VEHICLE RECALL

G-05521
December 2005

SUBJECT: SAFETY RECALL (U.S., EXPORT)
CAB ENTRY STEPS on certain CF500 and CF600
Models built 6/2/2004 thru 9/27/2005

Figure 2 – Reinforcement Placement

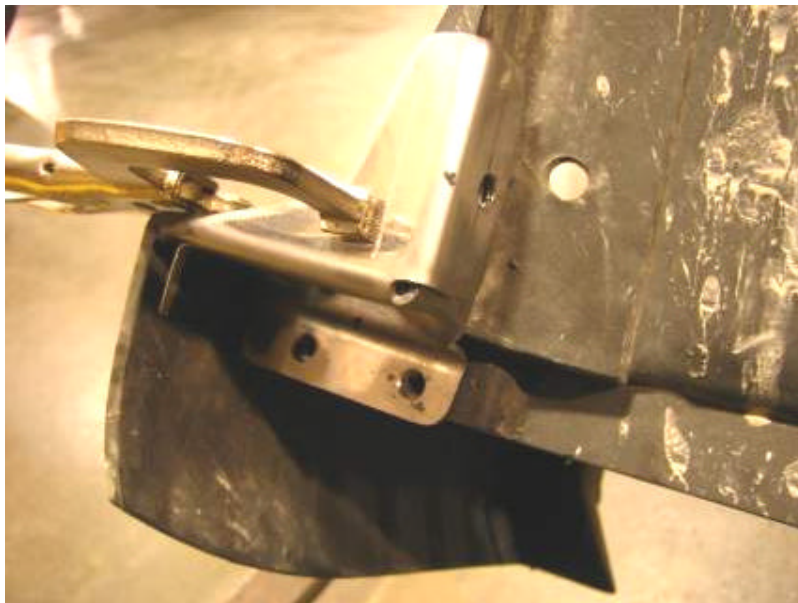
The cab entry steps were manufactured incorrectly causing them to have lower material strength properties than designed. These lower material strength properties can allow the step tread to fracture and separate from the vehicle under normal usage. Step-tread separation, while a person is entering or exiting the cab, may result in **property damage** or **personal injury**.

2. Attach reinforcement bracket to the inboard side of the step using a suitable clamp.
